SUBJECT: Supplement to Amendment Request NPF-38-249,
Extended Power Uprate
Waterford Steam Electric Station, Unit 3
Docket No. 50-382
License No. NPF-38

Attachment To
W3F1-2004-0029
Response to Request for Additional Information

**Response to Request for Additional Information
Related to the Extended Power Uprate**

**WESTINGHOUSE ELECTRIC CORPORATION
CALCULATED CAPABILITY CURVES
Waterford Unit #3 SES - Curve No. 660485**

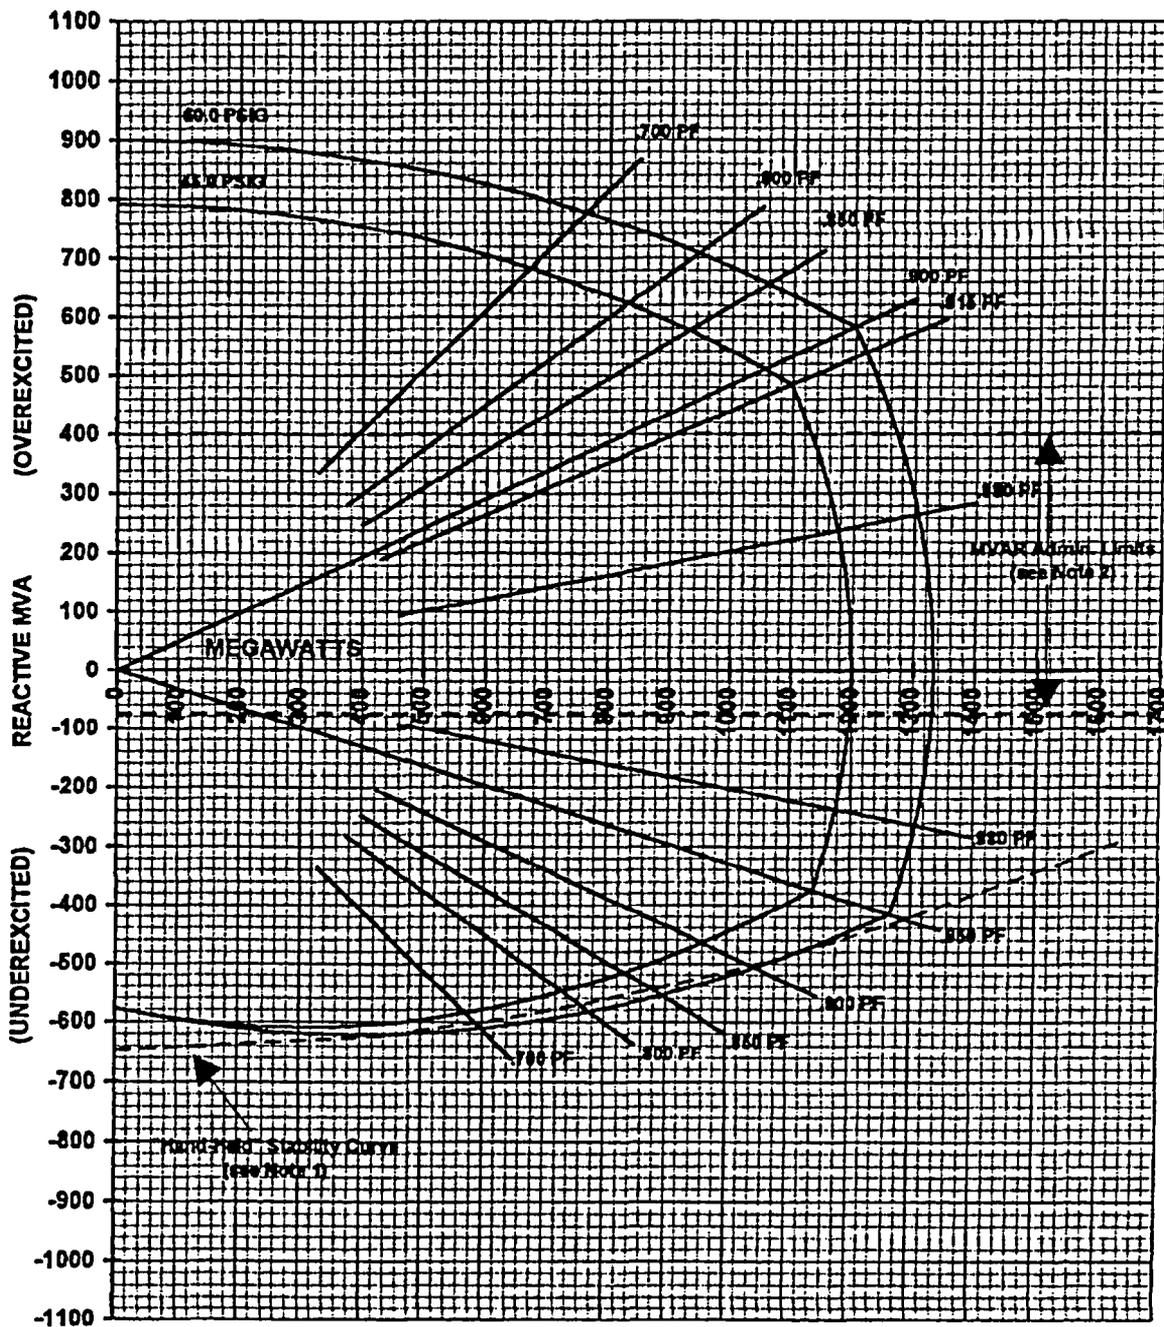
Address the compensatory measures that the licensee would take to compensate for the depletion of the nuclear unit megavolt-amperes resistive capability on a grid-wide basis.

Note: Based on conversations with the NRC staff, the following response addresses nuclear unit megavolt-amperes reactive capability on a grid-wide basis.

The present generator design is for a 1333.2 MVA (see attached generator capability curve) rating with the main transformers rated for 1200 MVA (FSAR Section 8.2.1 & Table 8.2-1). The generator is being rewound to restore the original design (i.e., 1333.2 MVA) which can accommodate EPU conditions. The main transformers and switching station are being modified as necessary to support the full 1333.2 MVA generator post uprate conditions as discussed in power uprate report (PUR) Section 2.3.2.2.

The pre-uprate nominal generator gross output is 1153 MW. The generator reactive output existing Administrative Limit is 400 MVAR which results in a power factor of 0.954.

The EPU electrical increase is targeted at 68 MW. The system interconnection and offsite studies assumed a conservative output of 1249 MW for the post-uprate generator gross output. The generator nominal reactive output capability for this output would be 466 MVAR or a power factor of 0.937. The analyses assumed a conservative value of 400 MVAR during the evaluation.
